# Access Compliance Report

## Public Rights-of-Way

Intersection ID: 42988	Main Street: UNIVERSITY_CITY_BV	Cross Street: UNIVERSITY_WALK_CR	Location: SE
ADA ID: 3B5ED382F340	Ramp Type: Perp	Initial Pass/Fail: Fail	Overall Compliance: No
Codes/Mitigation Info/Possible Solution			Severity Score: 25
			Field Measurements/Component Compliance

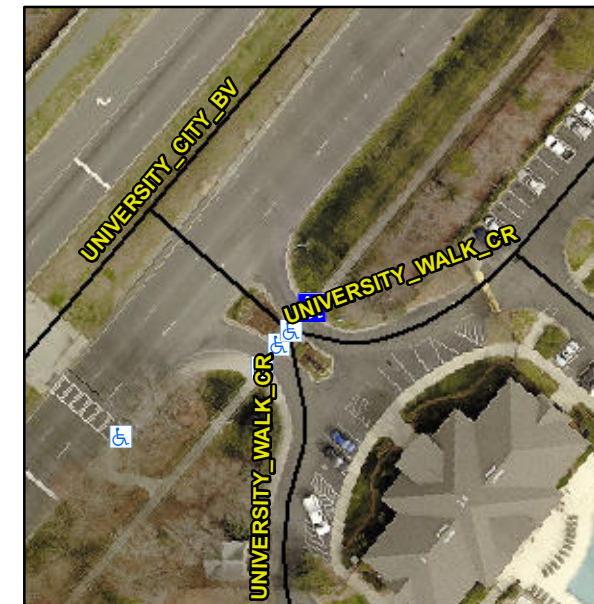
**Not Found, R304.2.2**

Compliance	Description	Data	Compliance	Description	Data
N/A	Ramp Length (in)	50.0	No	Ramp Slope (%)	14.5
Yes	Ramp Width (in)	62.0	Yes	Ramp XSlope (%)	1.5
N/A	Flare Type LT	N/A	N/A	Flare Type RT	N/A
N/A	Flare Slope LT (%)	N/A	N/A	Flare Slope RT (%)	N/A
N/A	Flare Traversable LT?	N/A	N/A	Flare Traversable RT?	N/A
N/A	Landing Length (in)	N/A	N/A	DWS Provided?	N/A
N/A	Landing Width (in)	N/A	N/A	DWS Contrast?	N/A
N/A	Landing Slope (%)	N/A	N/A	DWS Length (in)	N/A
N/A	Landing X Slope (%)	N/A	N/A	DWS Full Width?	N/A
N/A	Landing Curb? (Y/N)	N/A	N/A	DWS Offset (in)	N/A
N/A	Shared Landing?	N/A			
N/A	Gutter Ponding?	N/A	N/A	Gutter Slope (%)	N/A
N/A	Gutter Lip Ht (in)	N/A	N/A	Gutter X Slope (%)	N/A
N/A	Painted X Walk1?	Yes	N/A	Painted X Walk2?	N/A
	X Walk 1 Direction	To SW		X Walk 2 Direction	N/A
N/A	X Walk 1 Width (in)	57.0	N/A	X Walk 2 Width (in)	N/A
	X Walk 1 Slope (%)	1.1		X Walk 2 Slope (%)	N/A
	X Walk 1 X Slope (%)	4.8		X Walk 2 X Slope (%)	N/A

**Remove & Replace Entire Ramp.**
